Testimony on the Staff Report on the Westwood Shopping Center Preliminary Plan Amendment #12017017A and Kensington of Bethesda Senior Living Site Plan #820200200

Submitted by the Westbard Study Group for the Planning Board Hearing 12.17.20

Testimony on the Staff Report on the

Kensington of Bethesda Senior Living Site Plan #820200200

Figure 1: Kenwood Tributary outlet to the Willett Branch at River Road, adjacent to the Westwood Center II parking lot

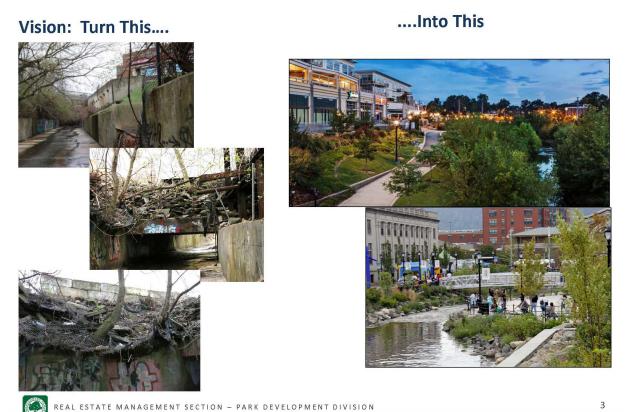
An important part of the Sector Plan is daylighting the Kenwood Tributary where it meets the Willett Branch and creating a waterfall-like feature at that juncture. This is not a hard sell if you recall the Figure 1, the picture of the confluence of the waterways. The best time to create this feature is concurrent with the road alignment and the construction of the new building. The Kenwood Tributary runs under River Road, and will have to be redirected when the road is moved. It runs under the asphalt of the parcel being conveyed to the Park. The area will already be torn up and the heavy equipment needed to dig out the creek will be onsite. The incremental costs of daylighting while the road is being constructed and the pavement is being removed is small. The benefits to the community are huge.
